ISC-C1 Rack

Title		
ISC System Wiring Diagram		
Size	Number	Revision
B	D1900511	V10
Date:	8/13/2024	Sheet of 1 37
File:	C:\Users\...ISC_C1_SH1.SchDoc	Drawn By: Filiberto Clara

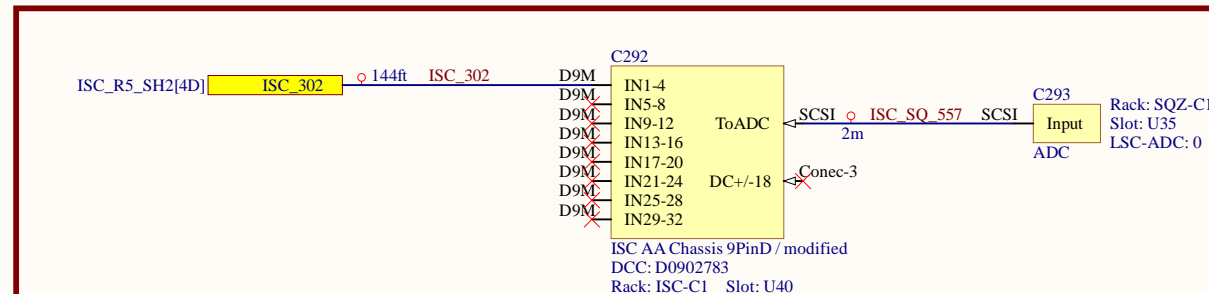
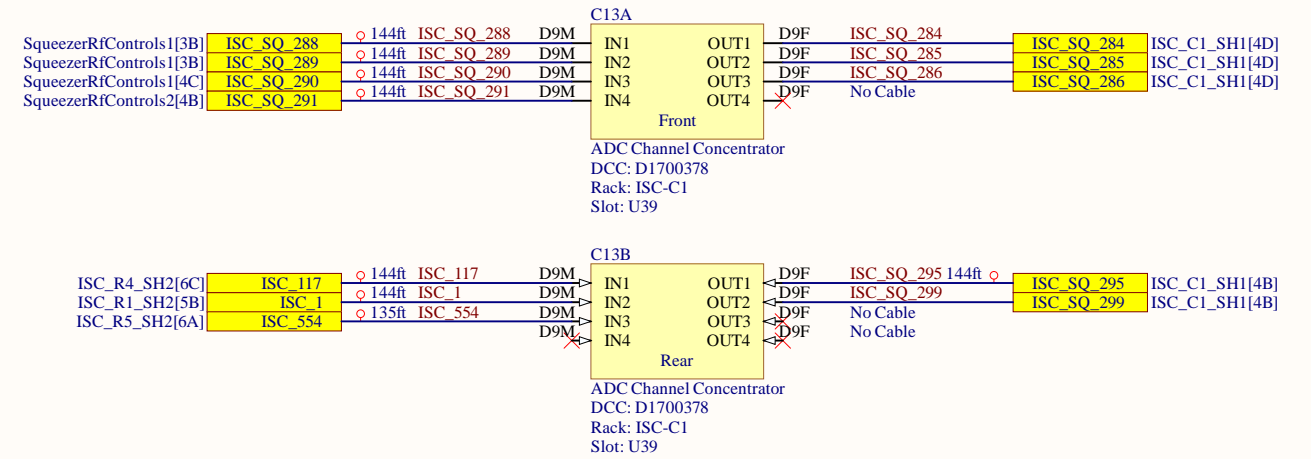
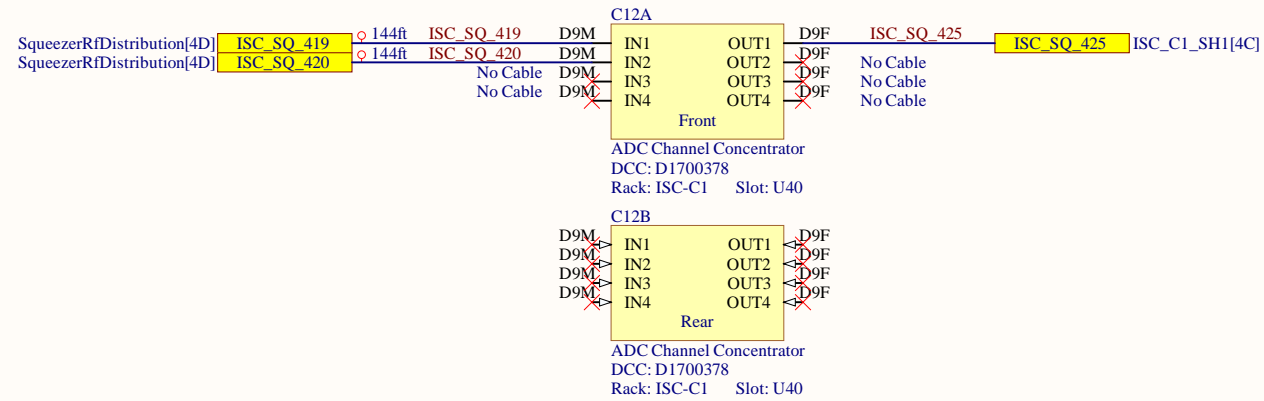
Following cables are not connected in the CER:
ISC_101, ISC_175, ISC_242, ISC_410.

ISC-C3 Rack

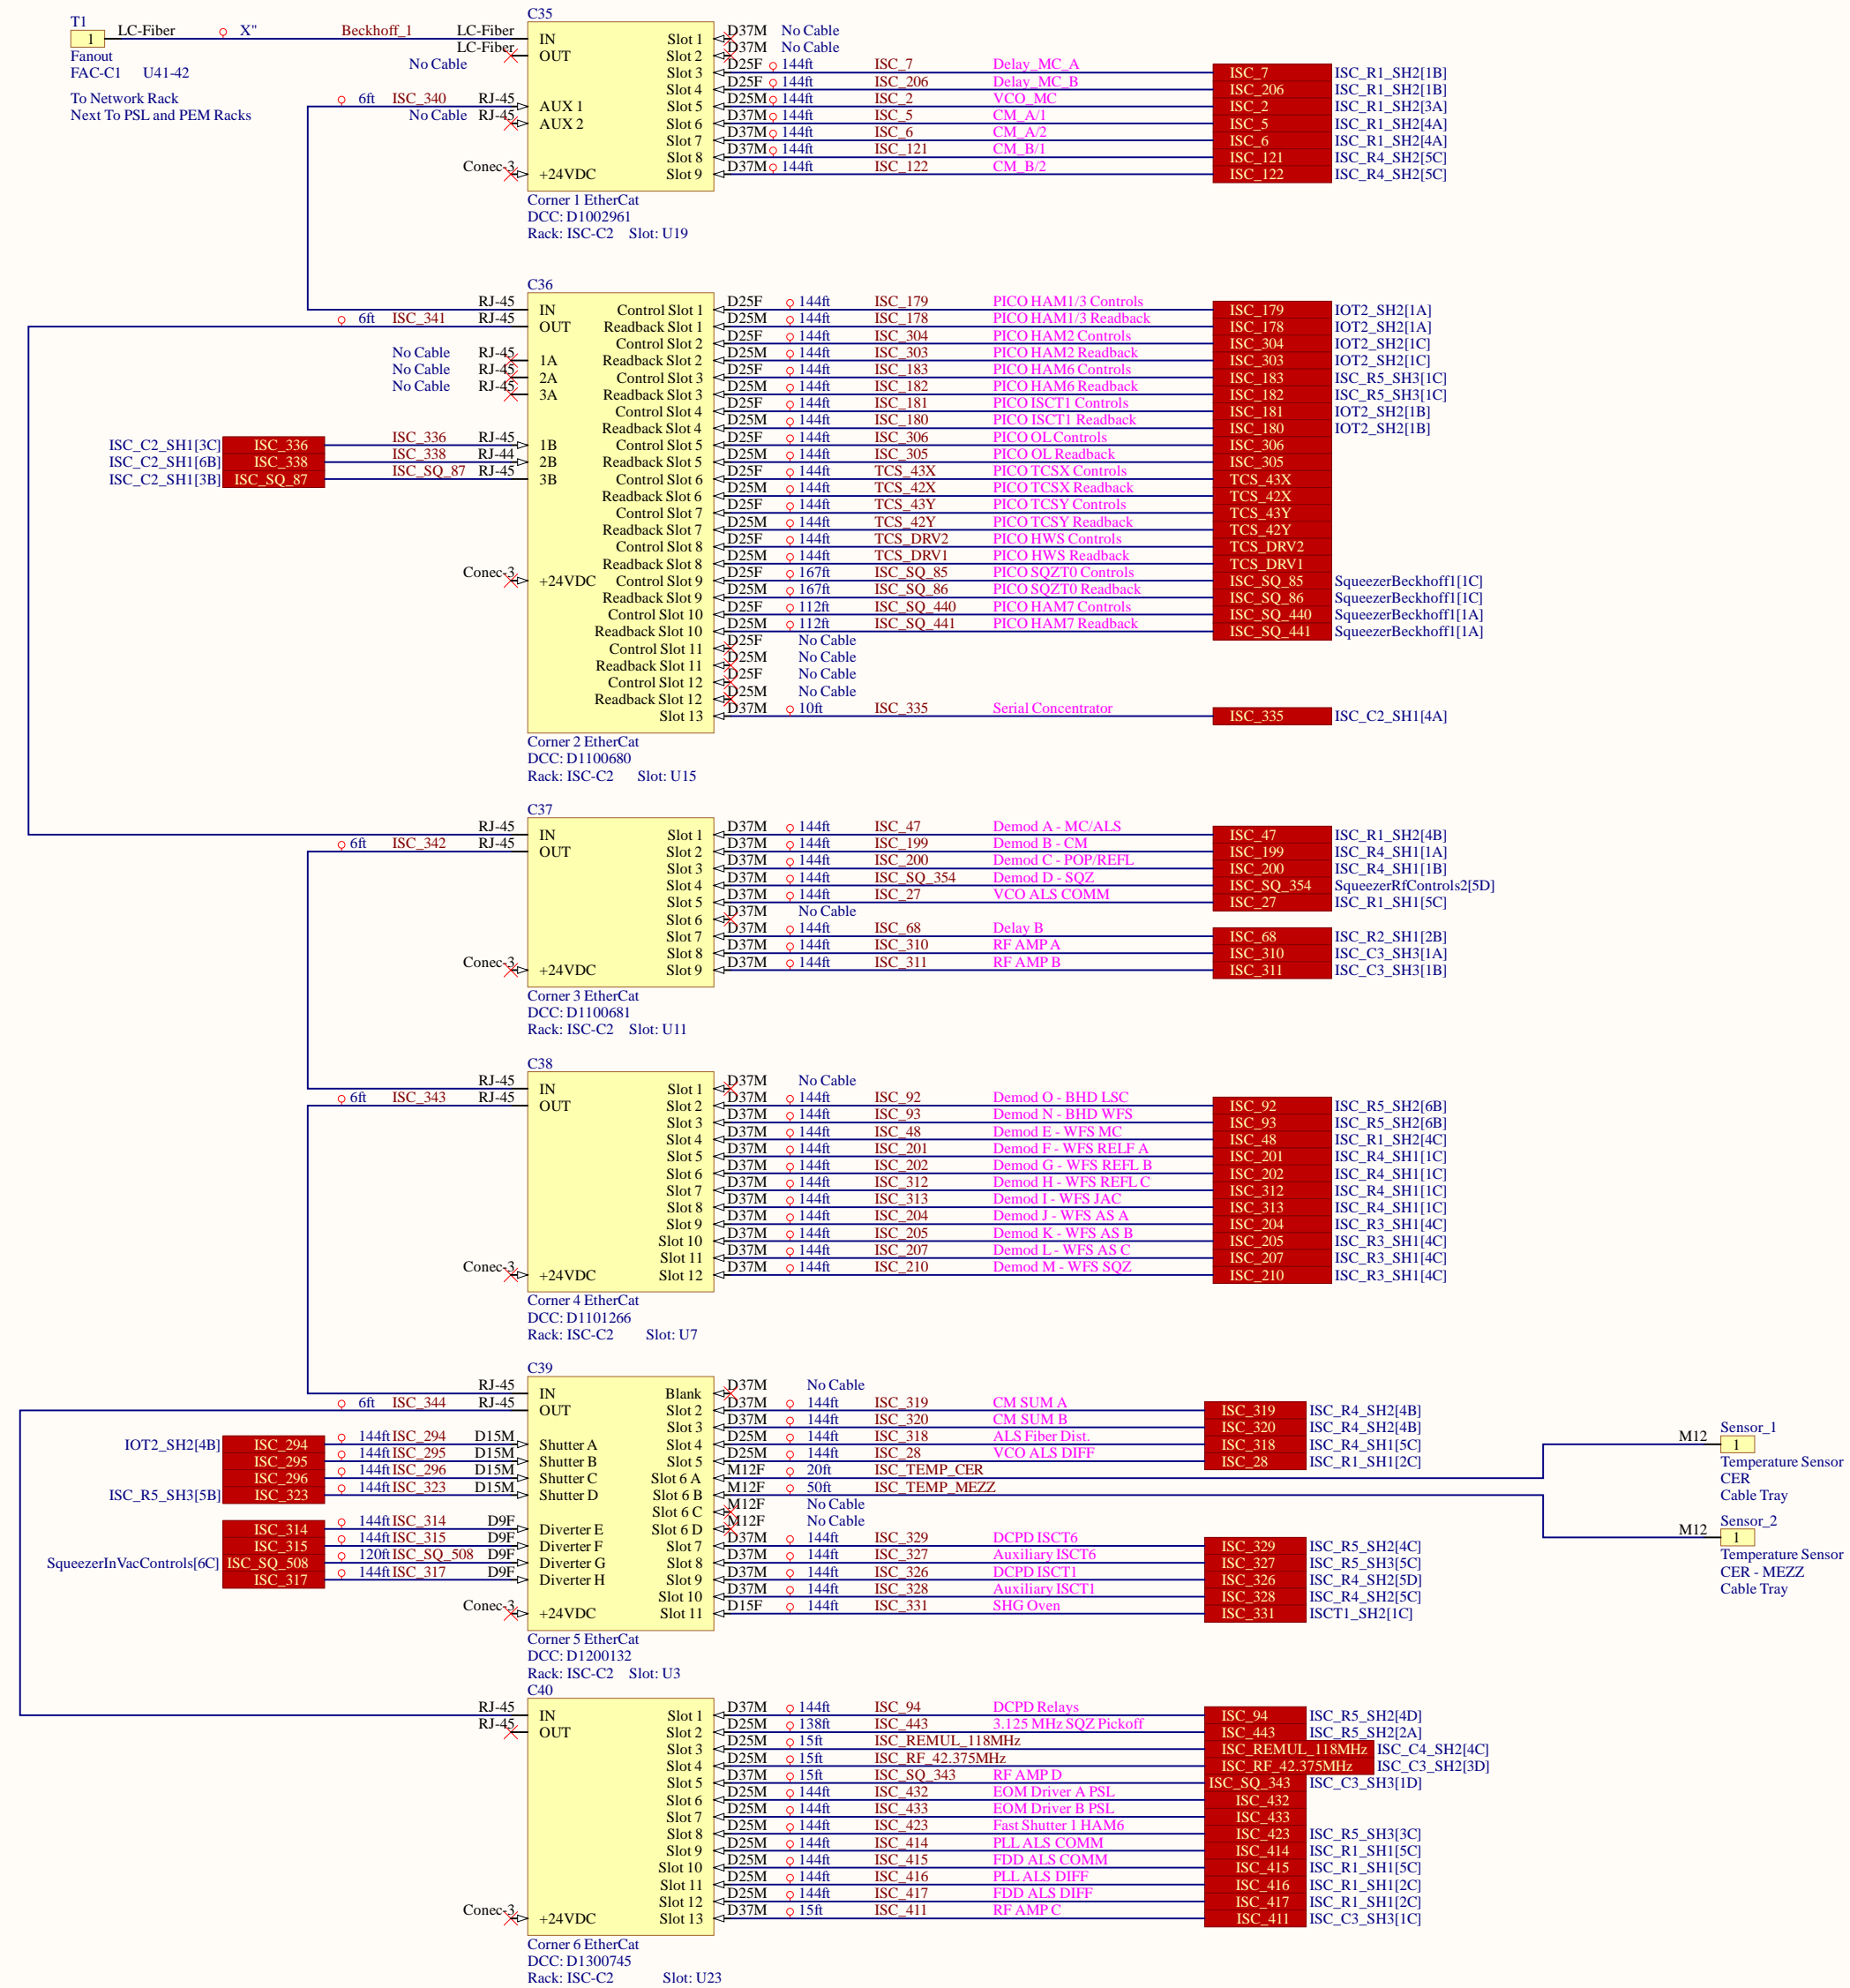
Cables that are removed
ISC_SQ_31
ISC_SQ_12
ISC_SQ_78

ISC-C3 Rack

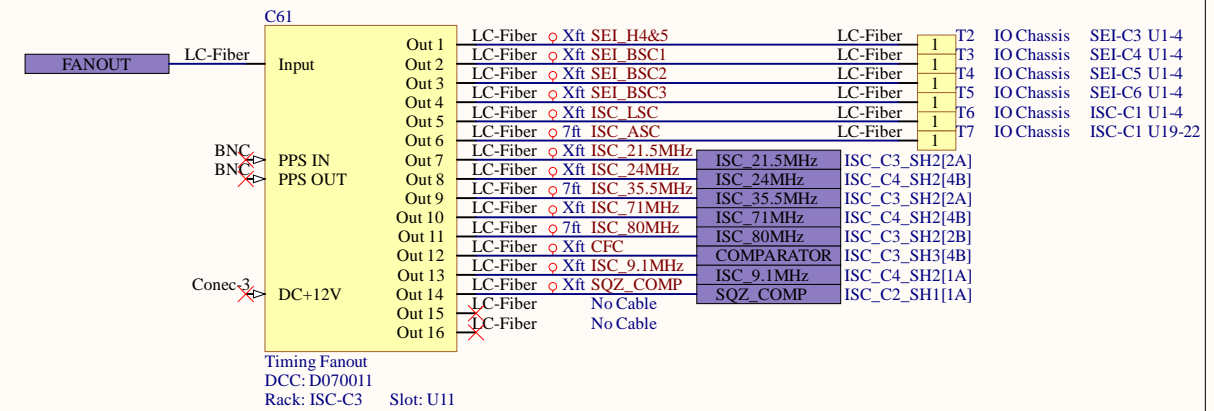
Need Locations of other ends.
 SEI IO Chassis

ISC-R1 Rack

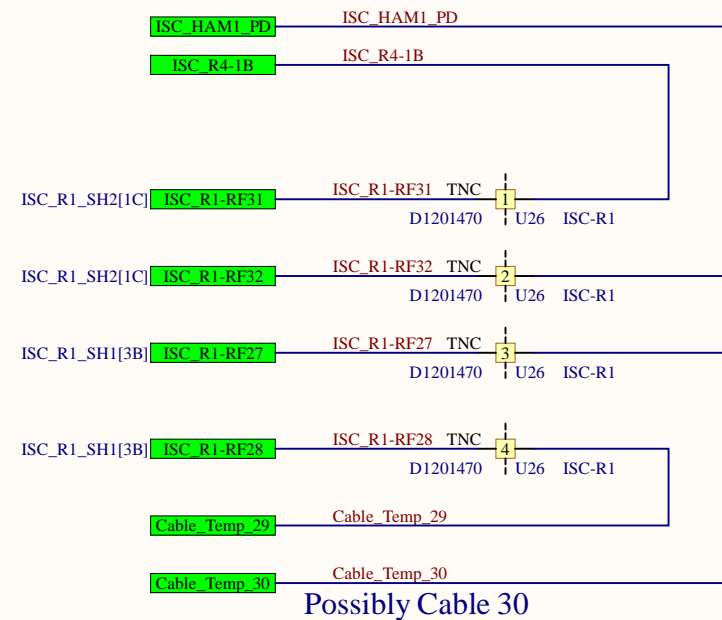
Need to label or find cable number

Recheck cables for U22
In back for PLL

ISC-R1 Rack

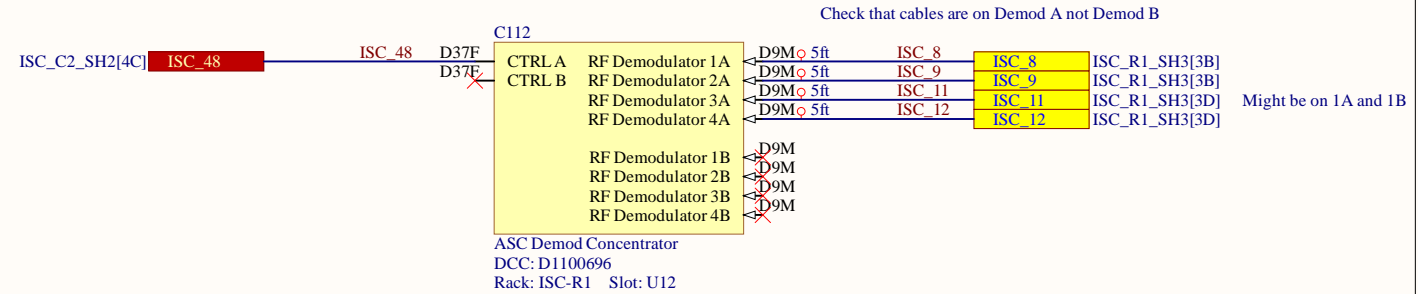
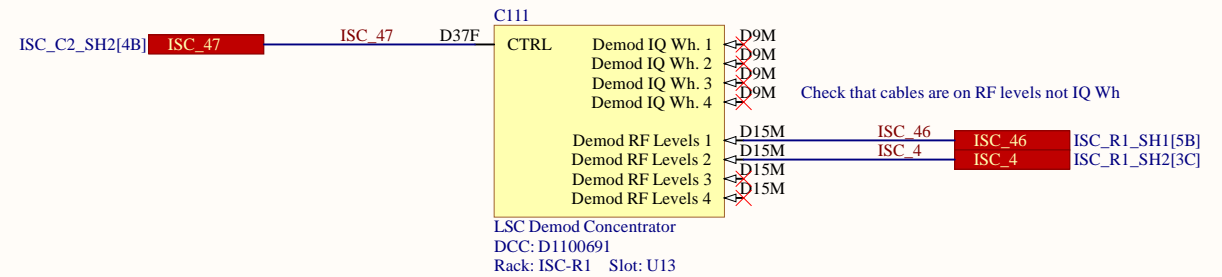
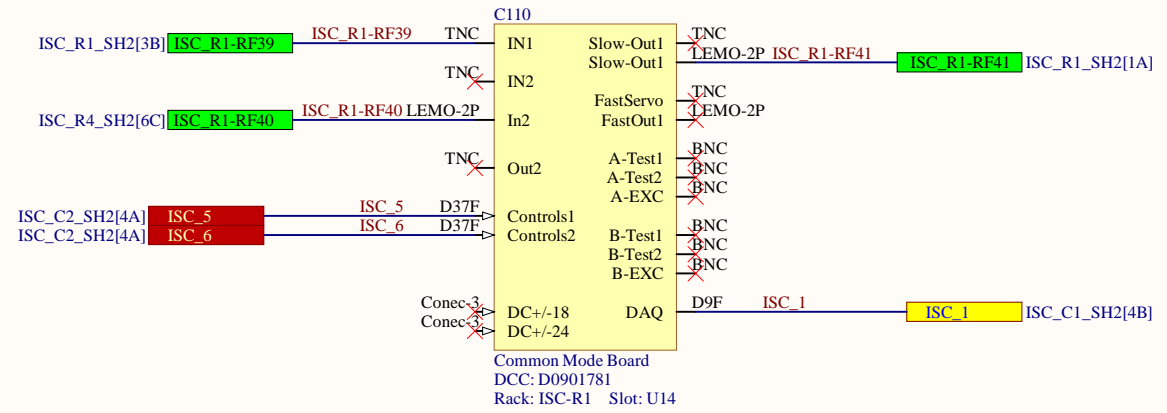
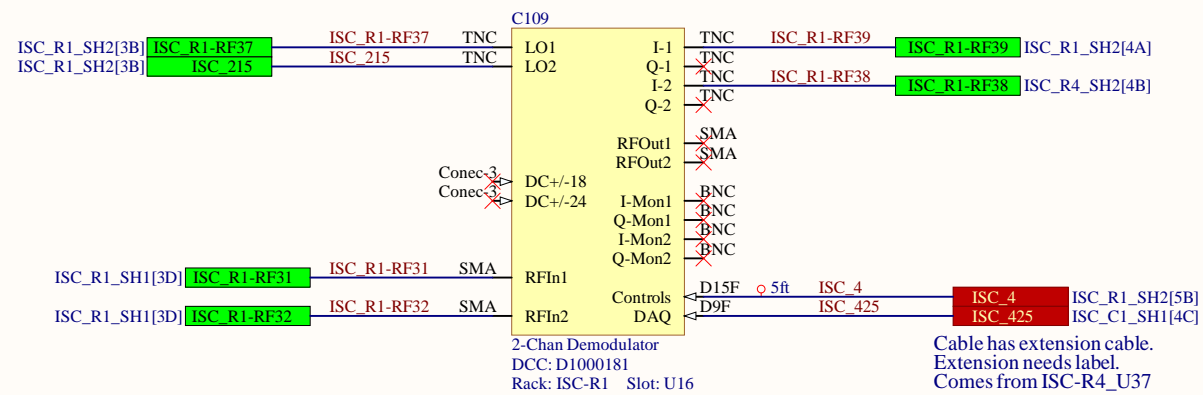
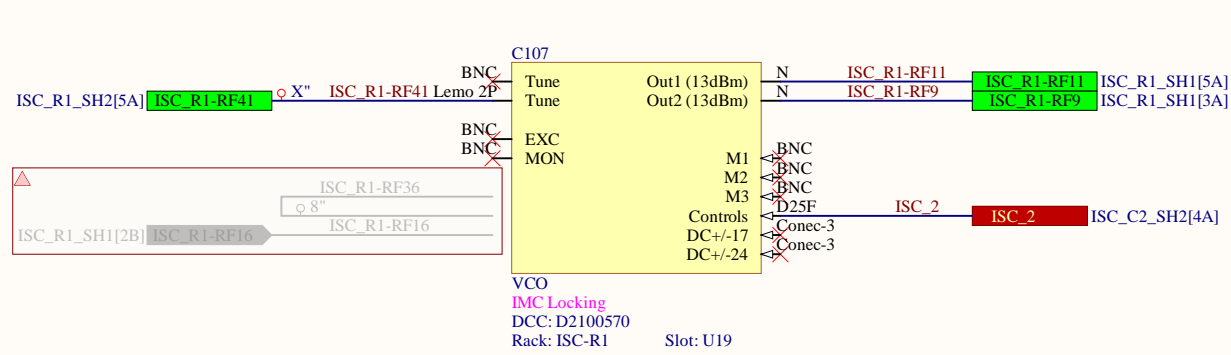
Need to Locate other end

ISC-R1 Rack

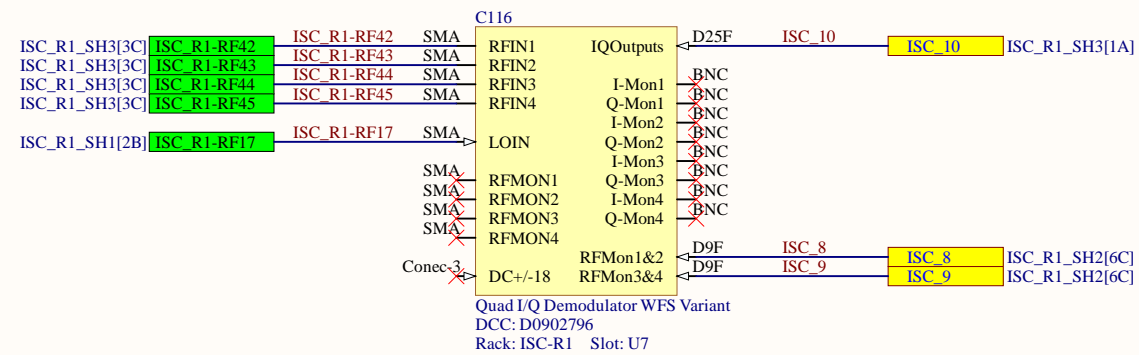
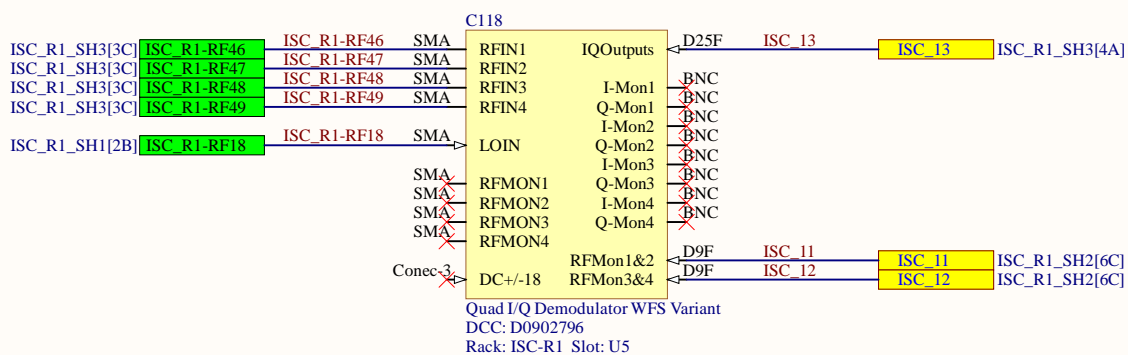
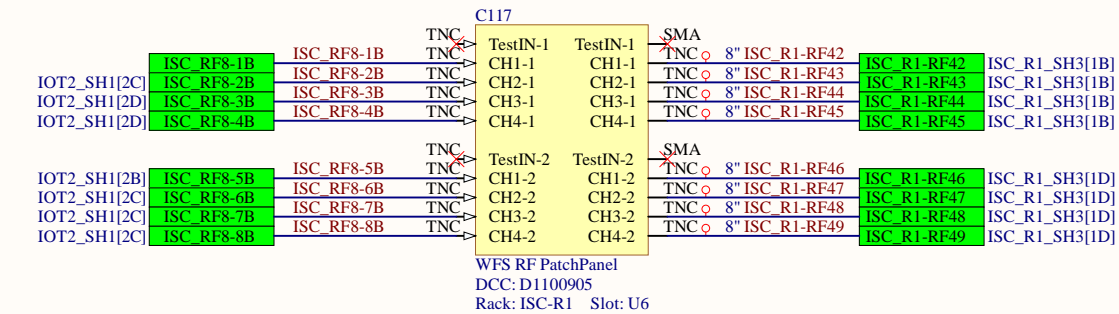
Need to locate other end

434/435 already used
 ASC-POP_X_PIT/YAW

ISC-R4 Rack

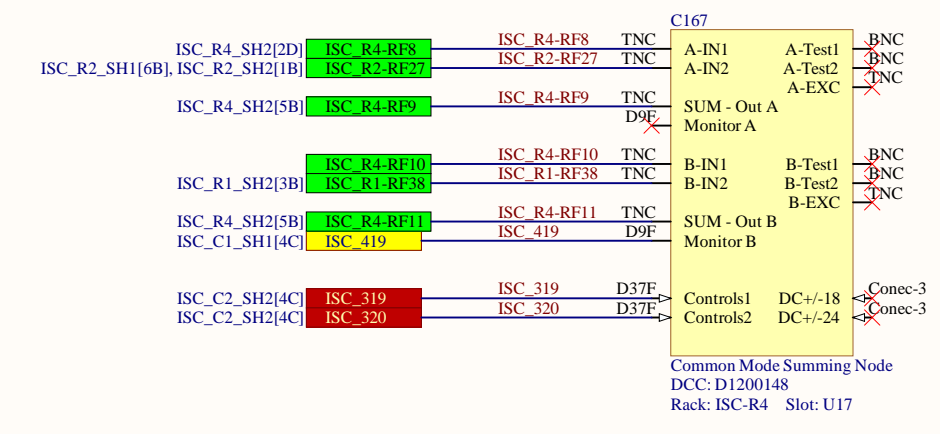
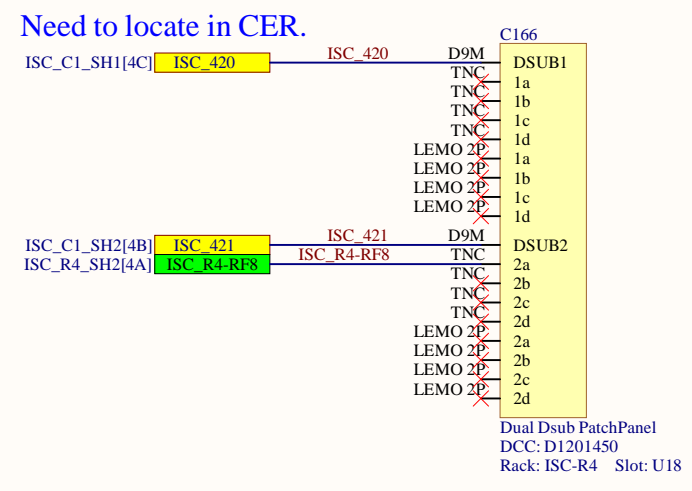
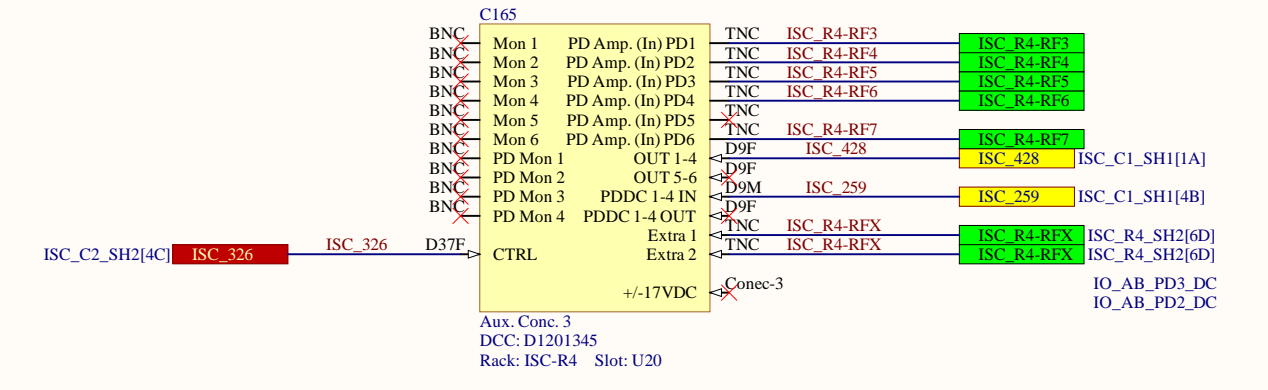
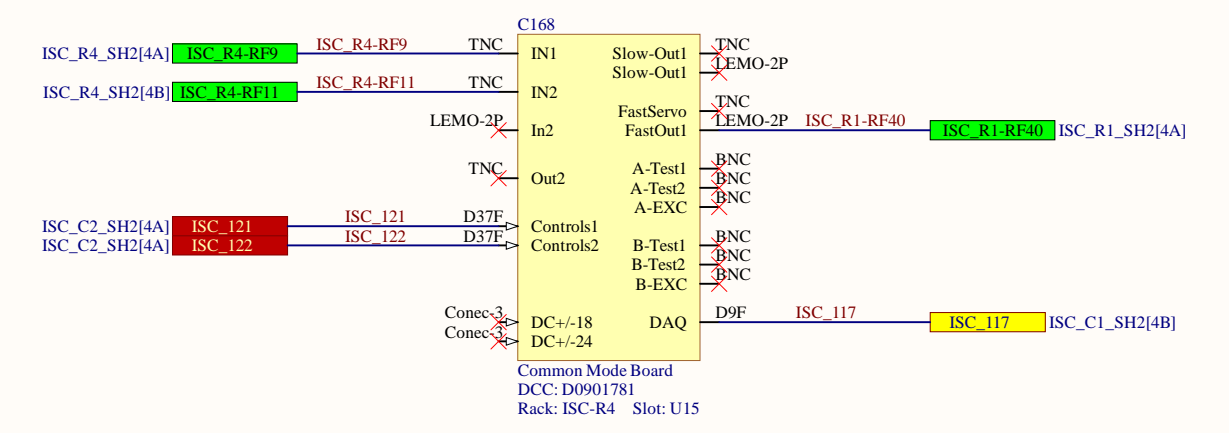
Do we need Sat Amp Included
 U23
 ISC_194 Coild Drive in CH1-4
 ISC_195 Coild Drive in CH5-8
 ISC_125 PD Out CH1-4
 ISC_126 PD Out CH1-4

Cable in the back.
 ISC_228
 ISC_229

Otherside not labeled. RED
 Otherside not labeled. Green
 Otherside not labeled. R4 ISC1
 Otherside not labeled. R4 ISC2
 Otherside not labeled. Old label H1_ALS_PSL_PD1
